# Access Compliance Report

## Public Rights-of-Way

Intersection ID: N/A	Main Street: SHASTA_LN	Cross Street: N/A	Location: W
ADA ID: 87F3E9A31492	Ramp Type: BlendTrans2	Initial Pass/Fail: Pass	Overall Compliance: No
		Severity Score: 2.5

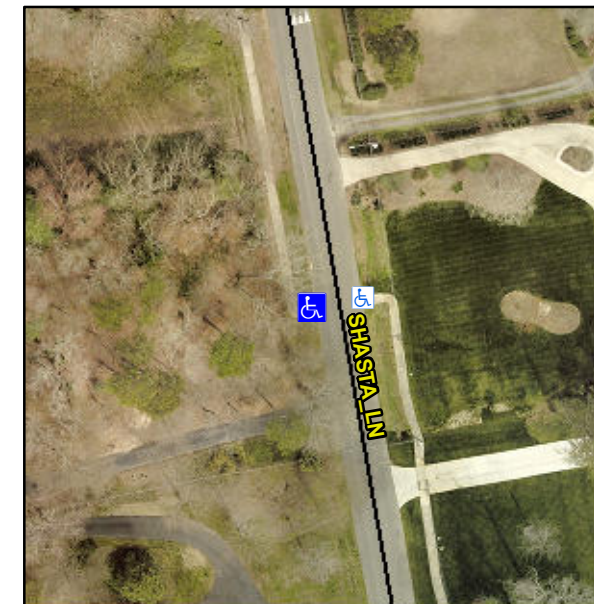
**DWS OS MEASURED TO ASP**

**R305.1.4, R305.2**

**Remove & Replace Detectable Warning System.**
